SUBJECT: ST. LUCIE UNIT 1 - ISSUANCE OF AMENDMENT RE: THERMAL MARGIN AND REACTOR COOLANT SYSTEM FLOW LIMITS (TAC NO. M95472)

Amendment No. 145
License No. DPR-67

SAFETY EVALUATION BY THE OFFICE OF NUCLEAR REACTOR REGULATION
RELATED TO AMENDMENT NO. 145 TO FACILITY OPERATING LICENSE NO. DPR-67
FLORIDA POWER AND LIGHT COMPANY, ET AL.
ST. LUCIE PLANT, UNIT NO. 1
DOCKET NO. 50-335

FIGURE 2.1-1: REACTOR CORE THERMAL MARGIN SAFETY LIMIT - FOUR REACTOR COOLING PUMPS OPERATING

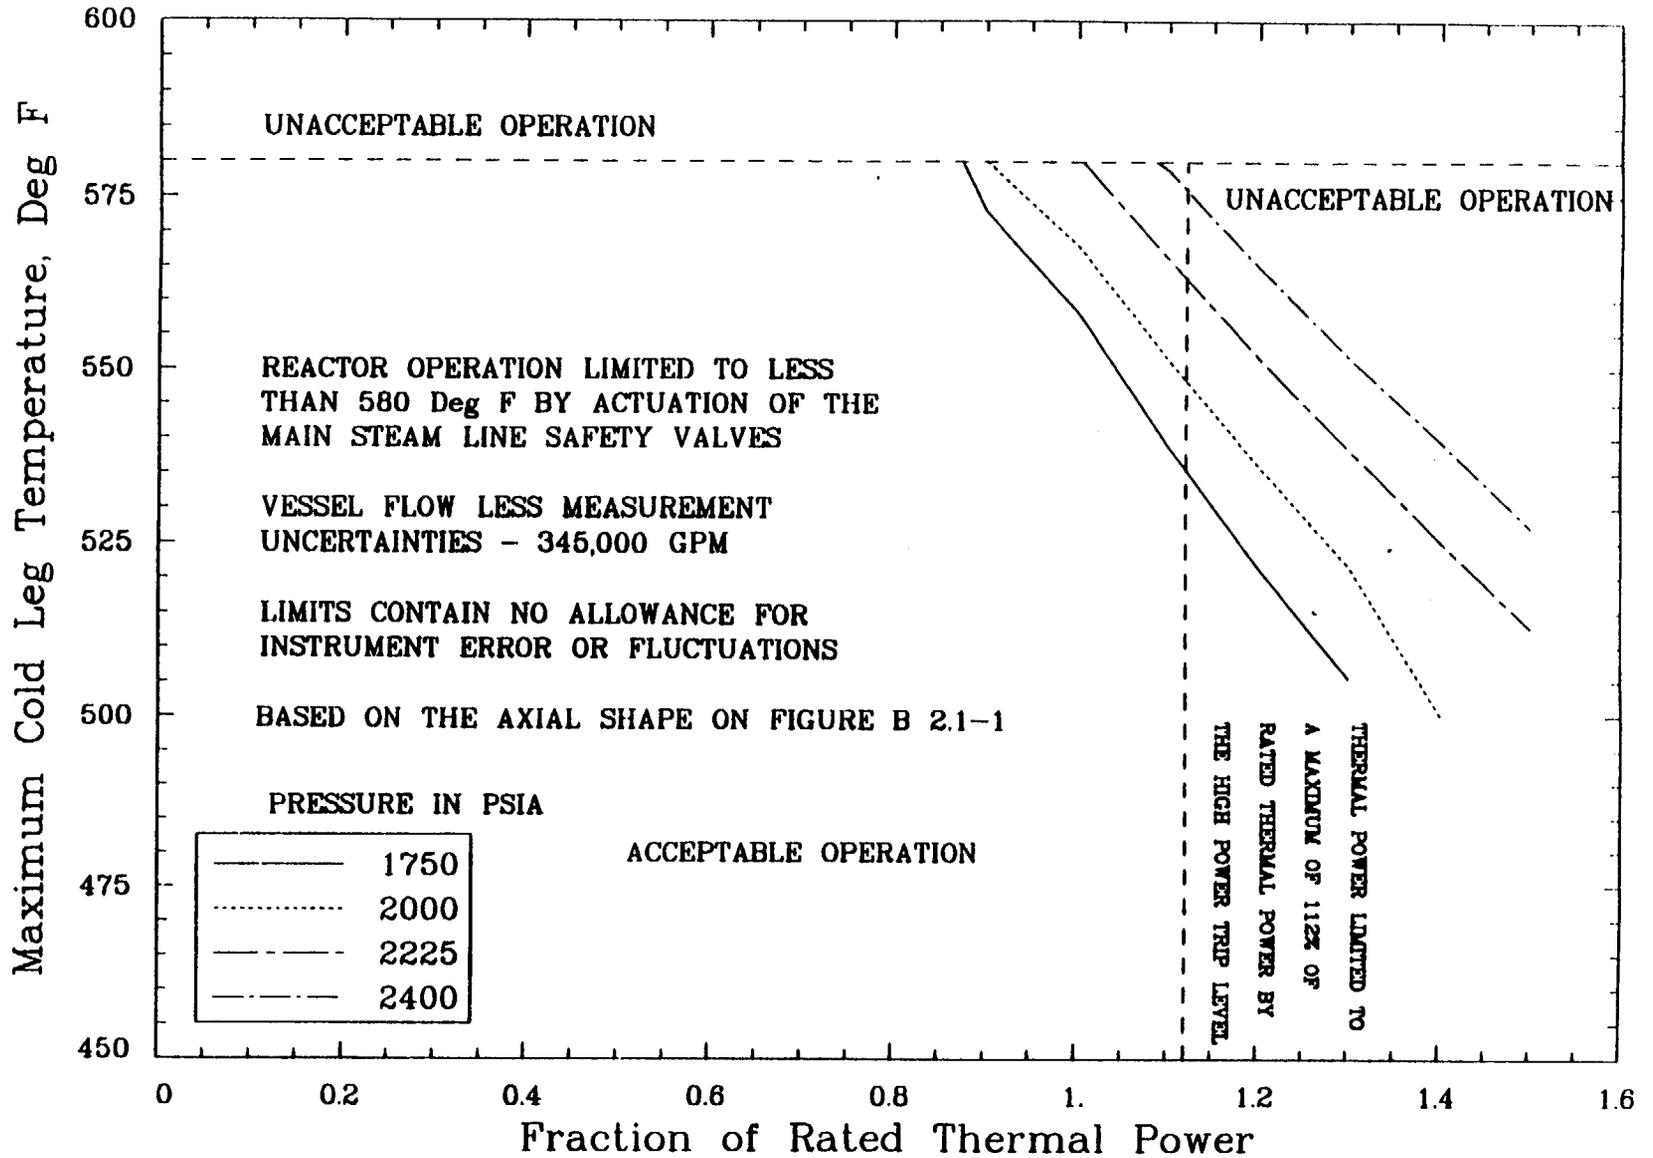
- (1) the design reactor coolant system (RCS) flow rate is reduced from 355,000 gpm to 345,000 gpm,
- (2) the reactor core thermal margin safety limits shown in Figure 2.1-1 are revised,
- (3) the reactor coolant system total water and steam volume described in the design features is modified,
- (4) the Limiting Safety System Setting (LSSS) for the reactor coolant low flow trip function is reduced from 95% to 93% of design reactor coolant flow, and
- (5) TS 2.1.1 is modified to limit reactor power to 90% rated thermal power for Cycle 14 operation exceeding mid-cycle fuel burn up conditions.

* For Cycle 14 operation beyond 7000 EFPH, THERMAL POWER shall not exceed 90% of 2,700 Megawatts (thermal).
- b. Page 2-2, FIGURE 2.2-1, Reactor Core Thermal Margin Safety Limit-Four Reactor Cooling Pumps Operating: This figure is replaced in its entirety with the revised FIGURE 2.1-1.

The "vessel flow less measurement uncertainties" is changed from 355,000 gpm to 345,000 gpm. The thermal limit lines have been revised to reflect the reduced flow.

The reactor core thermal margin safety limits given in TS Figure 2.1-1 have been adjusted to account for the proposed value of design flow, and define the areas of safe operation in terms of thermal power, RCS pressure, and cold leg temperature for which the DNBR is no less than the MDNBR limit. The minimum DNBR limit for steady state operation, normal operational transients, and anticipated transients remains unchanged from the existing, approved value of 1.22.
